UNITED STATES PATENT AND TRADEMARK OFFICE

APPLICATION NO.	FILING DATE	FIRST NAMED INVENTOR	ATTORNEY DOCKET NO.	CONFIRMATION NO.
09/748,277	12/27/2000	Jae-Lag Ma	8733.363.00	4729

DETAILED ACTION

Fig. 1

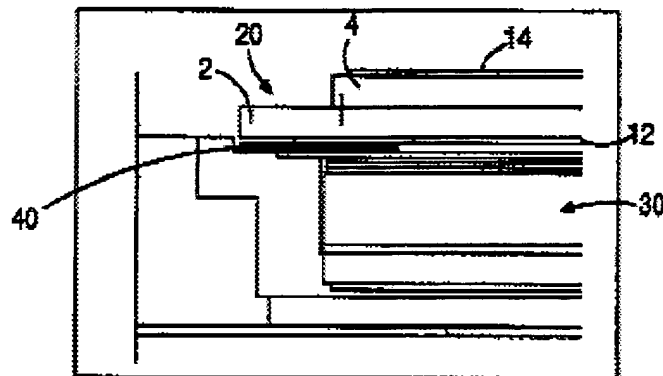
As to claims 6 and 9-13, APA discloses in Figures 1-4 (Specification pages 2-4), a dot matrix (Specification, Page 2, lines 18-22) liquid crystal display (LCD) device, comprising:

an upper polarizer, 14; on an upper substrate, 4, having a color filter (not shown, specification, page 3, first para);

a lower substrate, 2, on a lower polarizer, 12;

a liquid crystal layer (not shown) disposed between the upper substrate and the lower substrate; and

a backlight device, 30, disposed opposite and adjacent to the lower polarizer for emitting light toward the lower polarizer (Figure 1) (please note that adjacent does not

preclude structures between those items considered to be adjacent, e.g., two houses may be adjacent despite the existence of an intervening garage); wherein at least a black pad, 40, that acts as a light shield (Applicant's light shielding layer) formed in a rectangular shape having a substantially centrally located rectangular opening resulting in light shielding layer substantially shielding exclusively the peripheral portion (evident from Specification, Page 3, lines 11-14) of the lower polarizer to permit light to pass through the rectangular opening; wherein the light shielding layer only blocks a portion of the light traveling to four peripheral sides of the lower polarizer for minimizing constructive interference at a peripheral portion of the LCD device; and wherein the light shielding film absorbs light (inherent property of the color black).

APA does not explicitly disclose a lower polarizer that includes said light shielding film.

FIG. 3

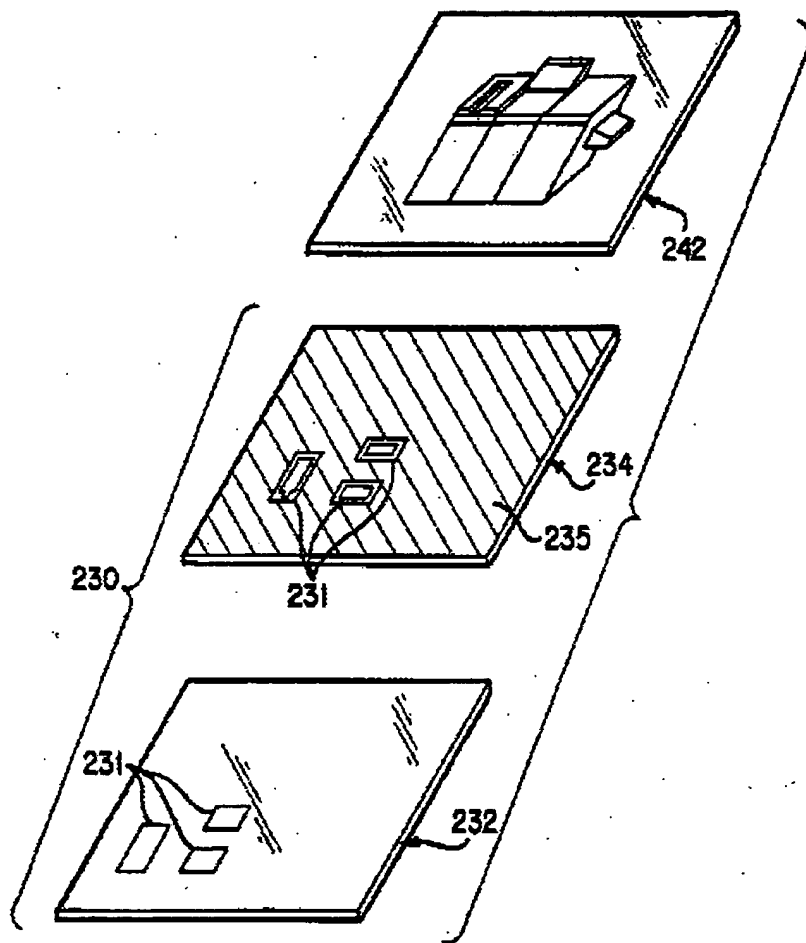
Dingwall teaches in Figures 2 and 3 (col. 5, lines 33-40 and col. 7, line 60 through col. 8 line 28), a liquid crystal display (LCD) device, comprising: a lower substrate, 236b, on a lower polarizer, 237b, that includes an opaque black mask, 235 (Applicant's light shielding film), to provide greater flexibility by first printing the black mask to define the image elements (or viewing area) with minimal alignment concerns to eliminate light leaks and allow the use of a true black mask rather than a gray mask

Dingwall is evidence that ordinary workers in the art of liquid crystals would find the reason, suggestion, or motivation to add a lower polarizer that includes an opaque black mask (Applicant's light shielding film) to provide greater flexibility by first printing the black mask to define the image elements (or viewing area) with minimal alignment

Therefore, it would have been obvious to one having ordinary skill in the art of liquid crystals at the time the invention was made to modify the LCD of APA with a lower polarizer that includes a light shielding film of Dingwall to provide greater flexibility by first printing the black mask to define the viewing area with minimal alignment concerns to eliminate light leaks and allow the use of a true black mask rather than a gray mask to provide a true dead front.

As to claims 7 and 8, Dingwall, as combined above, teaches (col. 8, lines 11-28) a liquid crystal display (LCD) device of claim 1, wherein the at least one opaque surround or black mask, 235, (Applicant's light shielding layer) is formed by a photographic process, by offset lithography (Applicant's coating), or by screen printing (Applicant's printed material) black mask materials that absorb the light (col. 8, lines 29-33, and col. 13, lines 25 and 26).
